ADDENDUM No. 1
Bid Package #1: Construction Documents
Encompass Architects, p.c.

Canopy Row
700 N St., Lincoln, NE 68508
NGC Group

EA Project No.: 16-1100

DATE OF ISSUANCE: February 8, 2017

M352

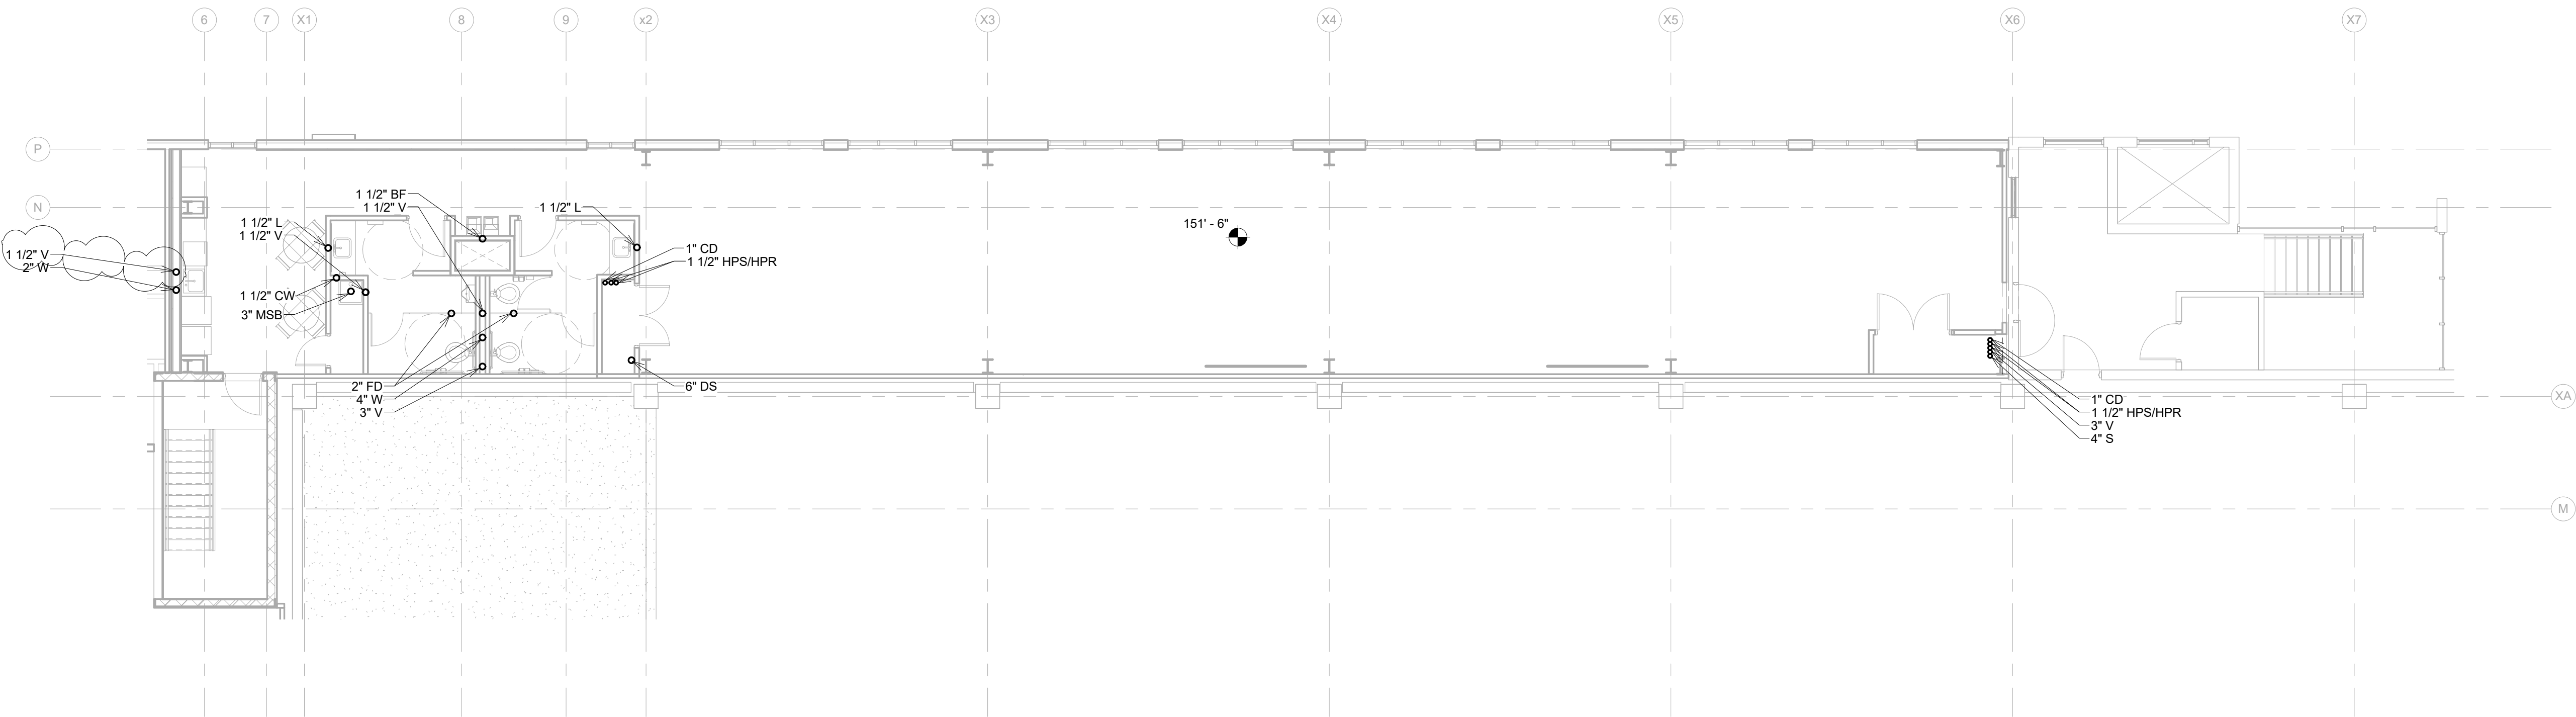
Added 1 ½" vent penetration through the floor for the vent stack for the kitchen sink in C500.

FIFTH FLOOR PENETRATIONS
ADDENDUM 1: ADD 1 1/2" V BY KS IN C500

1 BUILDING A WATER RISER DIAGRAM
NO SCALE

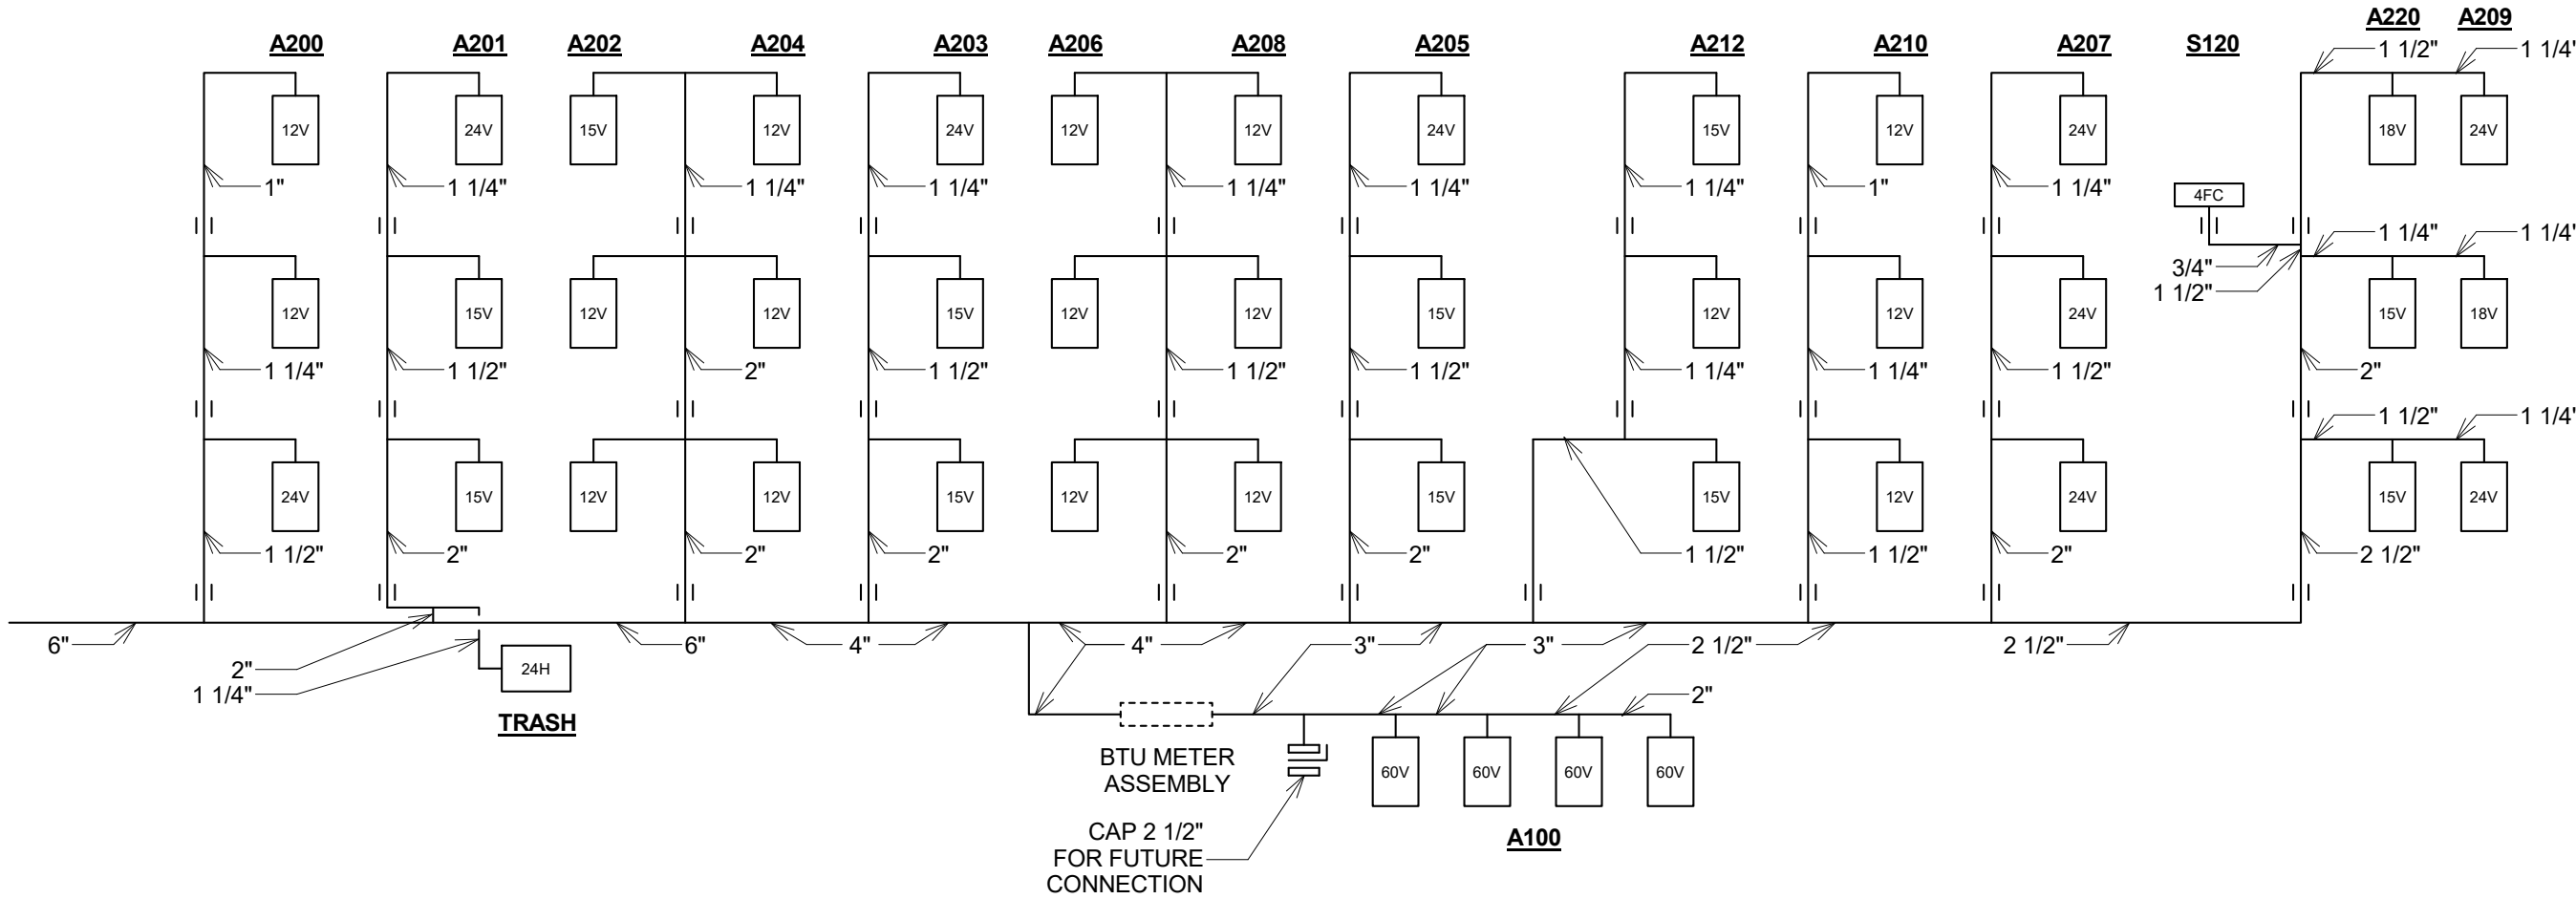
Building A Water Riser Diagram: Remove the requirement to provide a ½" cold water pressure control line from the end of the cold water main.

RISER DIAGRAMS-AREA A
ADDENDUM 1: REMOVE 1/2" CW PRESSURE CONTROL LINE FROM DETAIL 1 (WATER
RISER DIAGRAM)

1 BUILDING A WASTE & VENT RISER DIAGRAM-SOUTH END
NO SCALE

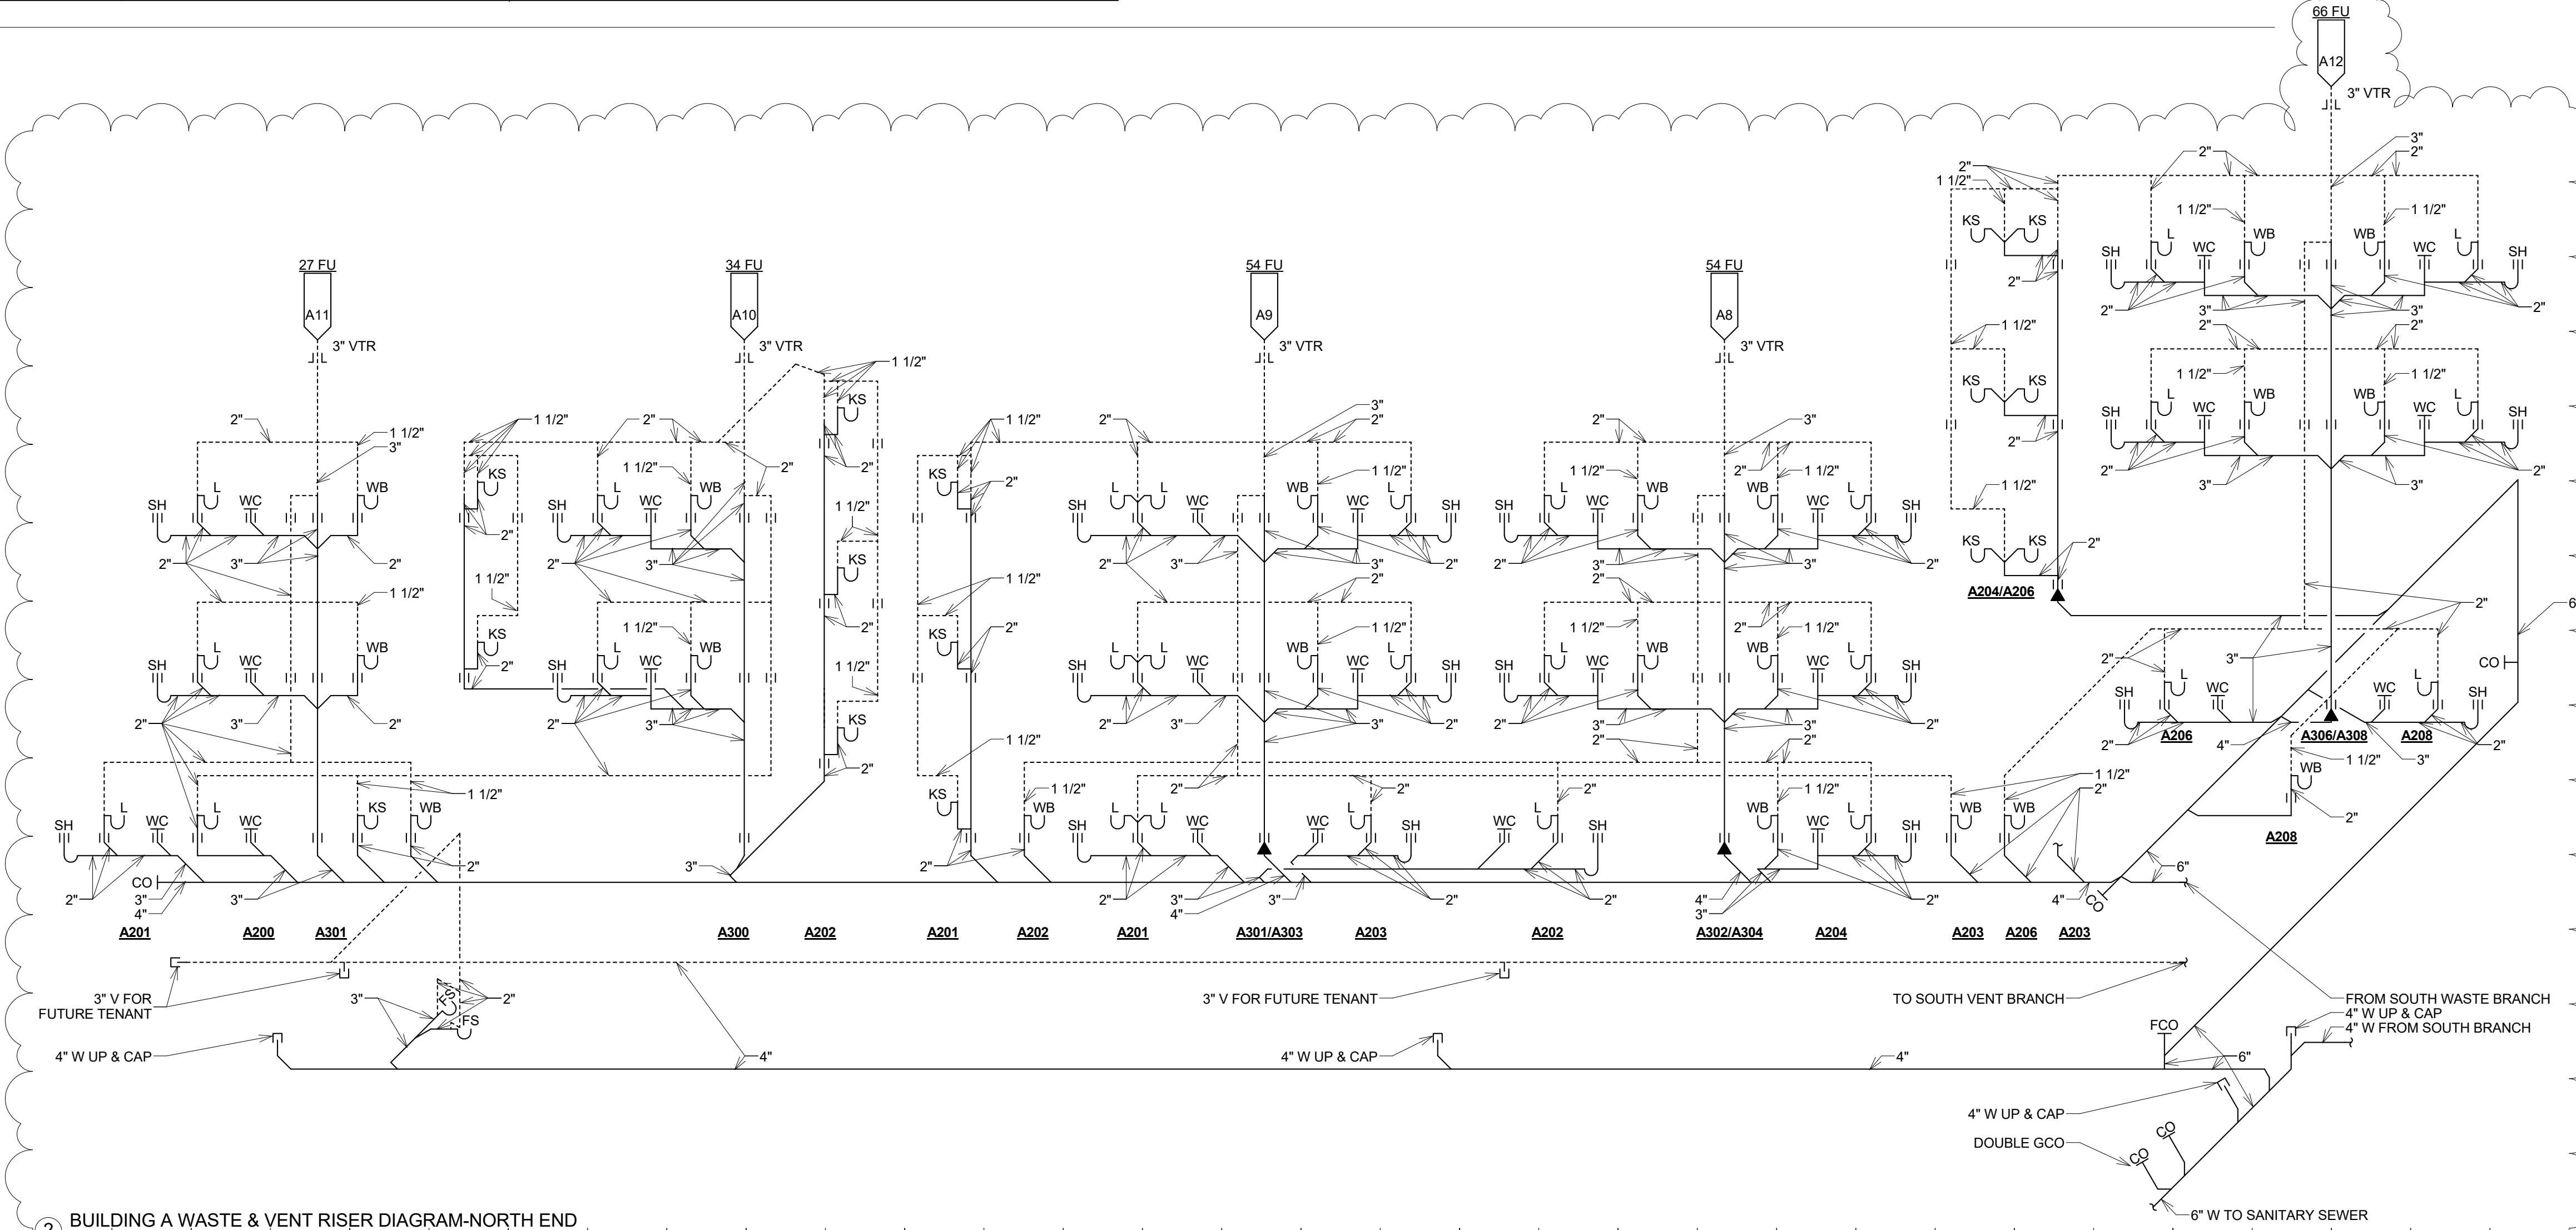
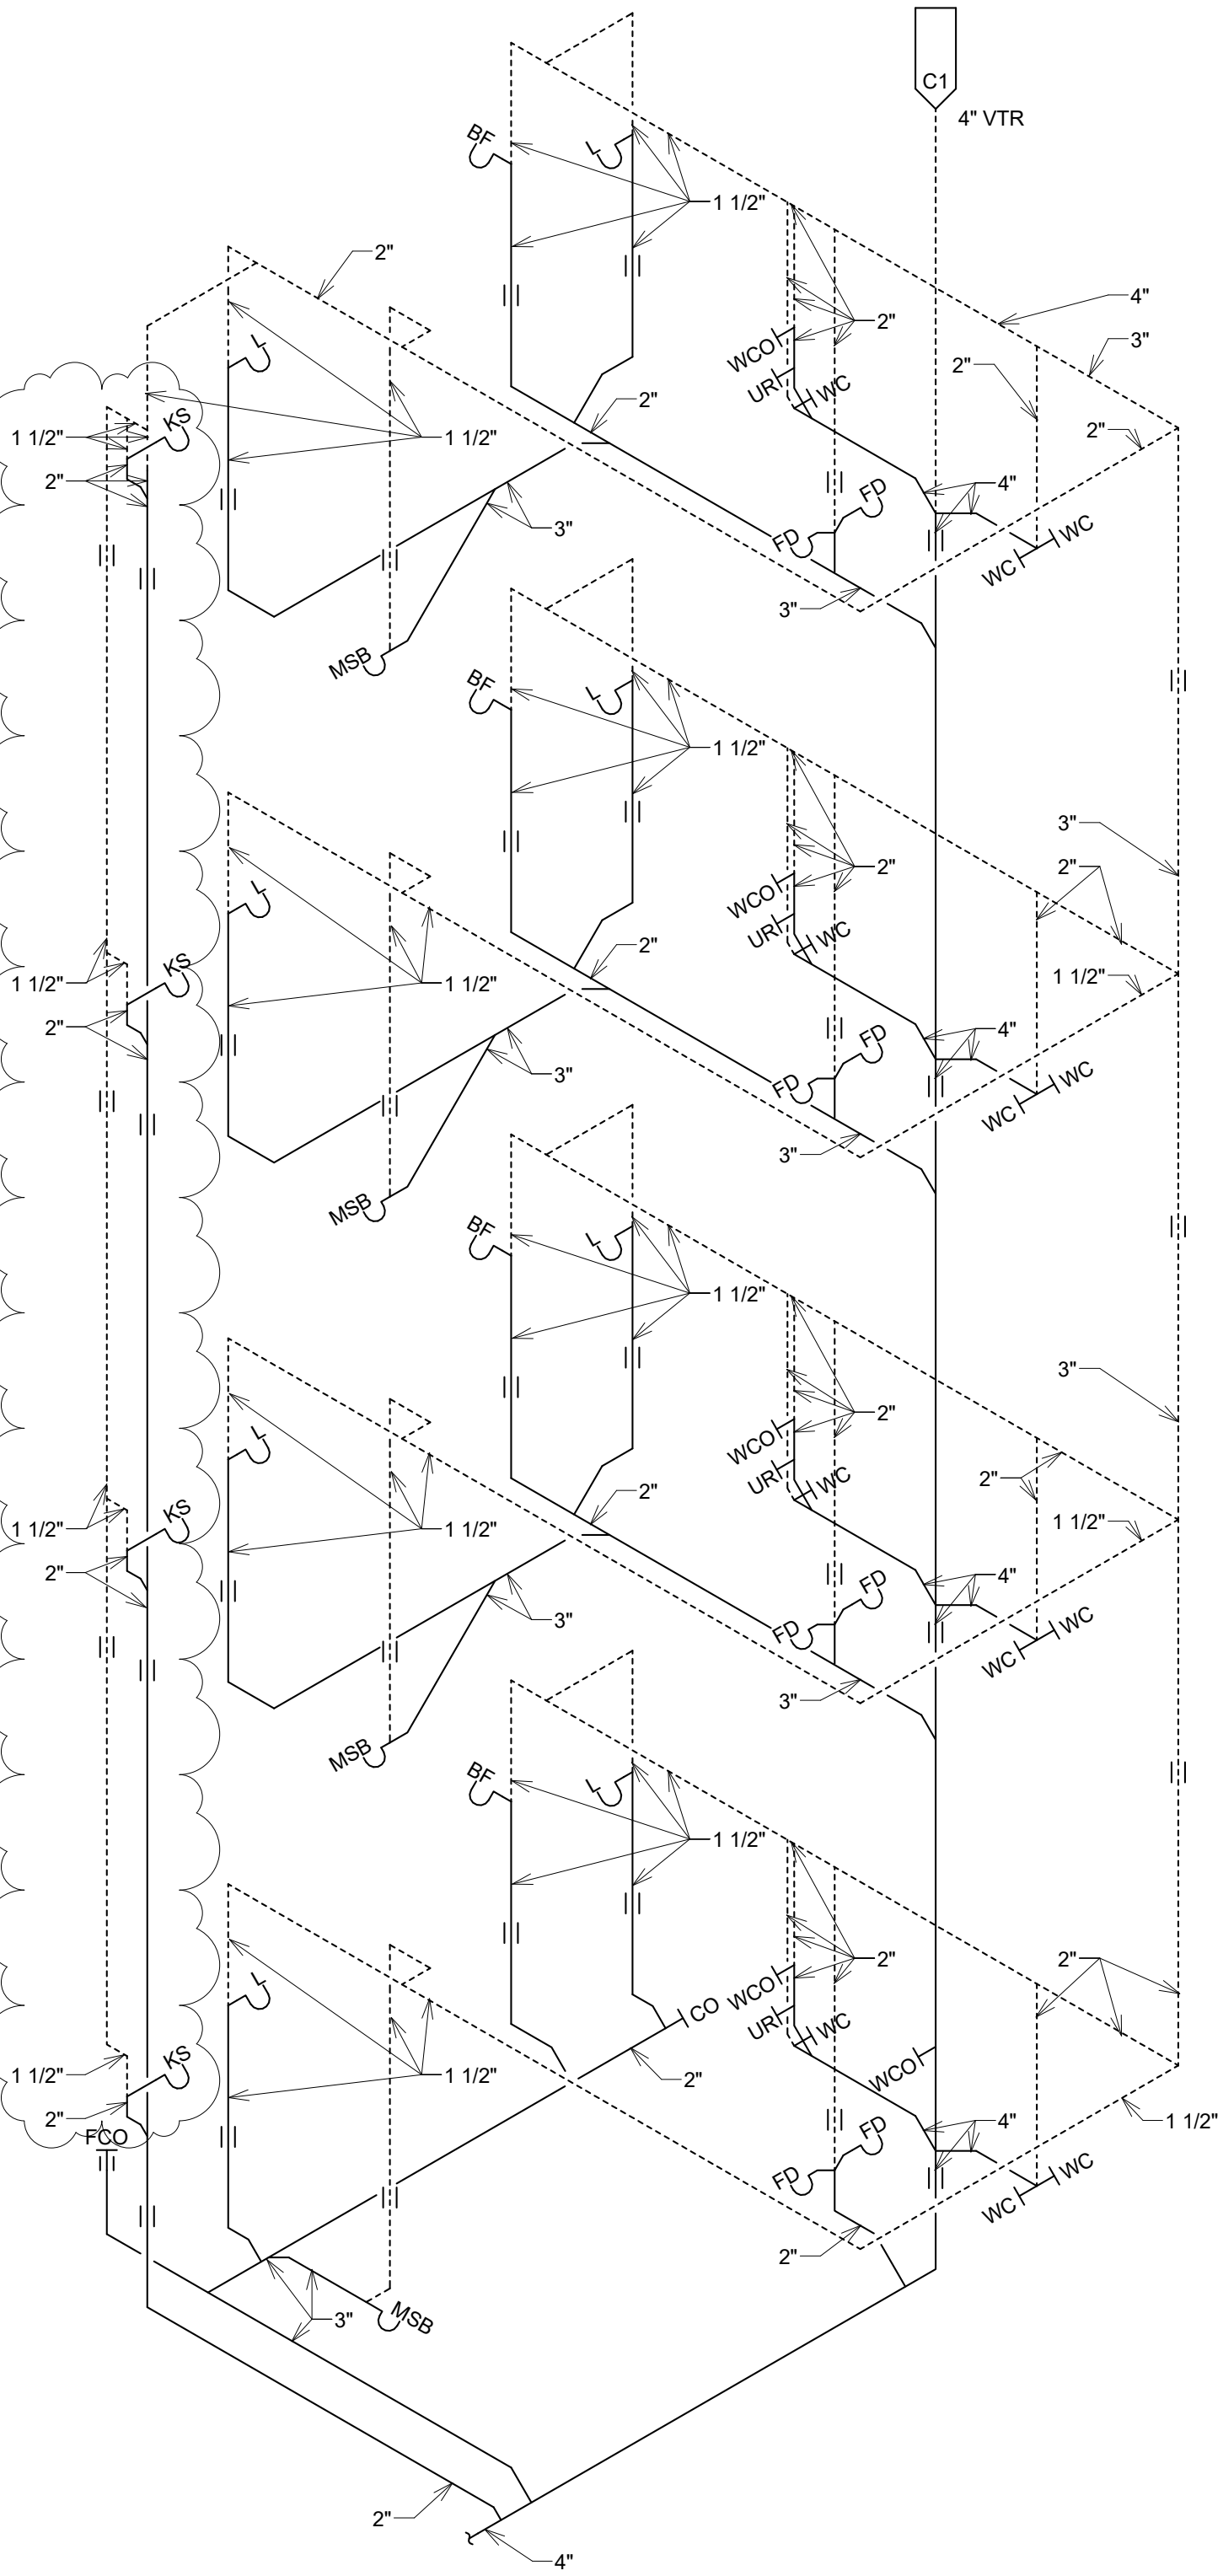
Building A Waste and Vent Riser Diagram-North End: Added riser diagram in its entirety.

Building A Waste and Vent Riser Diagram-South End: At the bottom of the 3" waste stack at Risers A303/A305, A305/A307 and A307/309 increases to 4" waste prior changing to the horizontal waste.

RISER DIAGRAMS-AREA A
ADDENDUM 1: ADD NORTH END RISER DIAGRAM (DETAIL 2); ADD PIPE REDUCERS TO
BOTTOM OF RISER A2, A3, & A7 WITH NOTE THAT PIPE UNDER IT IS 4" (DETAIL 1)
